Loren Corey Eiseley and  
Bess Jackson Wolf  
Branch Library  
Window Shade Package  
Lincoln, Nebraska

## ADDENDUM NO. 2

Eiseley and Walt Branch Libraries Window Shades Package  
Lincoln, Nebraska  
TCEP Project No.: 227-101-03

Addendum #2  
Supplemental Drawing: A-1  
Revision of Sheet: A3  
TOTAL P.02

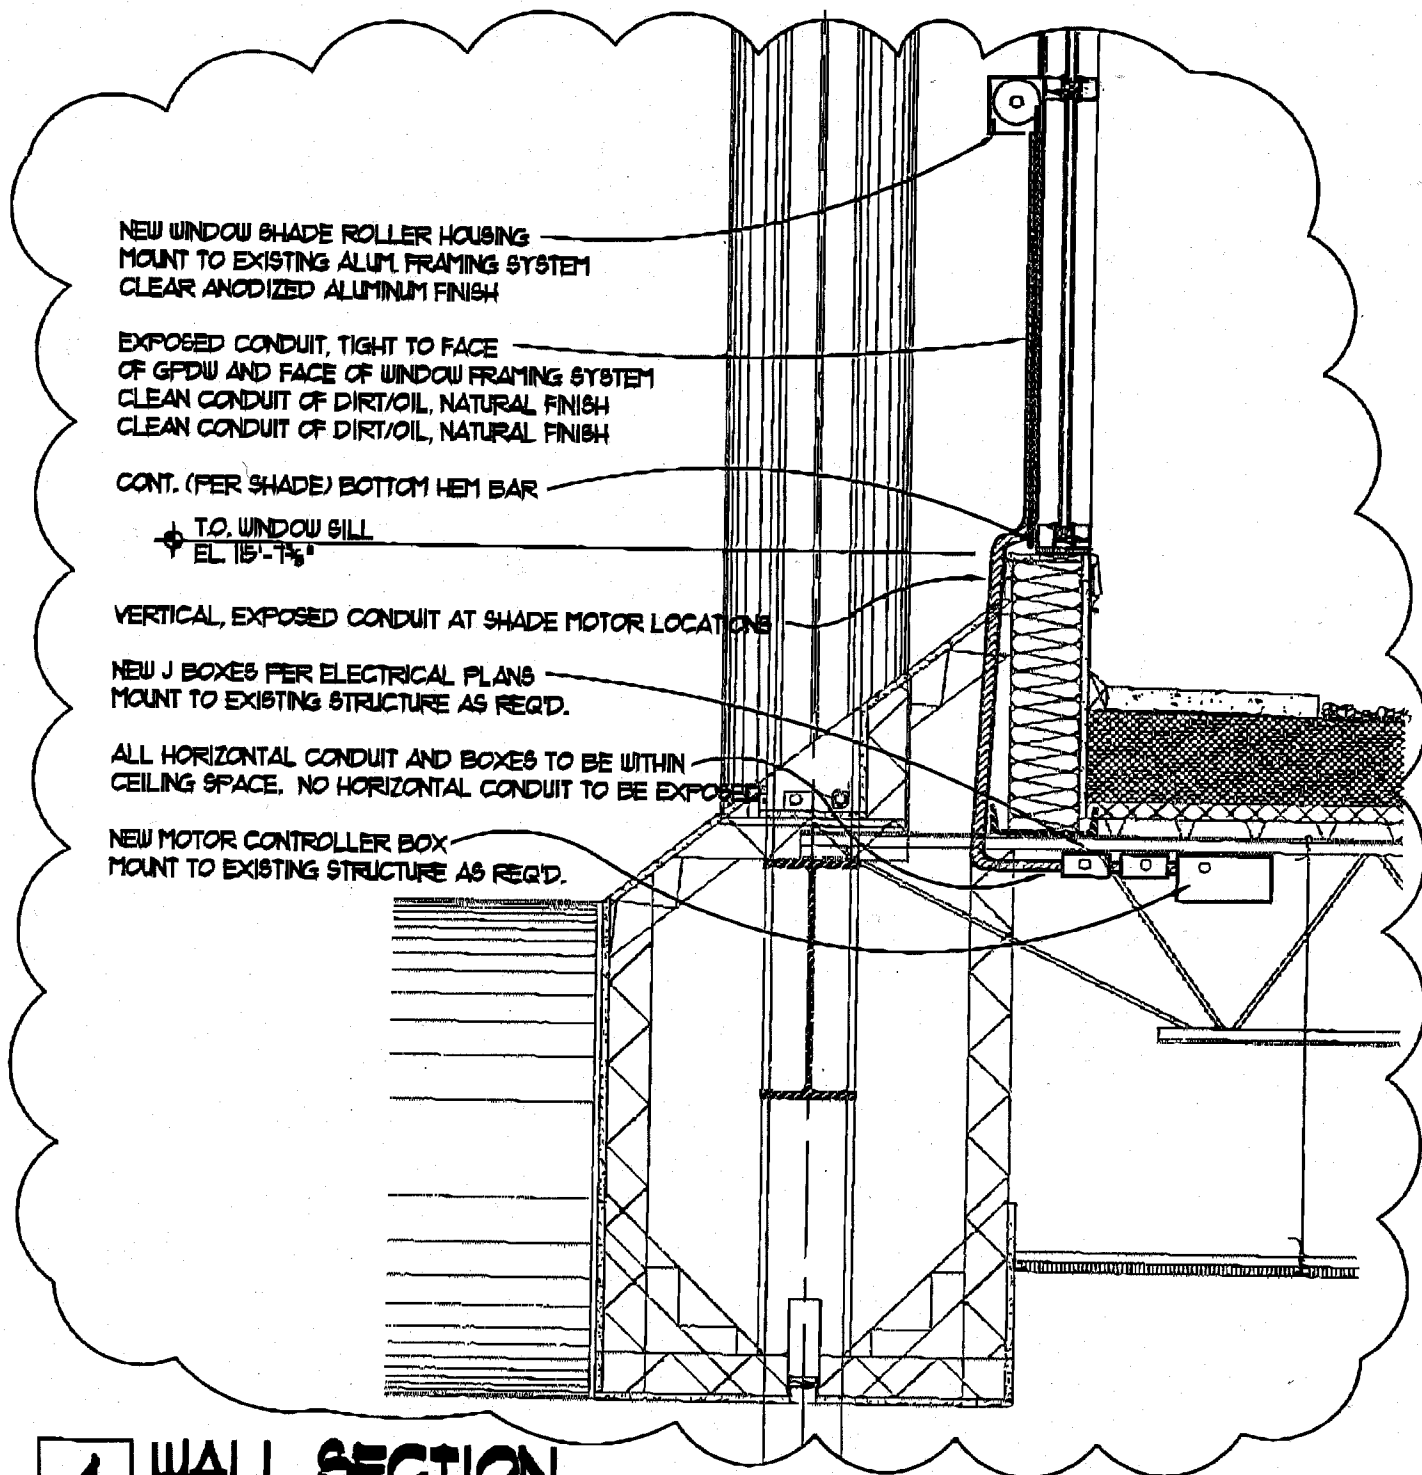
**Item 2-1: Supplemental Drawing SD-1**

Note: Contractor's Option per Shade System Mfr's requirements:

If shade system allows sufficient lead length between shade motor and motor controller, conduit, j boxes and motor controller boxes may be located above the ceiling as shown on Supplemental Drawing A-1. Note: all horizontal conduit and boxes to be located above the ceiling and not exposed. Conduit shall be exposed only where vertical runs extend to shade motor locations. Vertical conduit shall be held tight to gpdw and window frames.
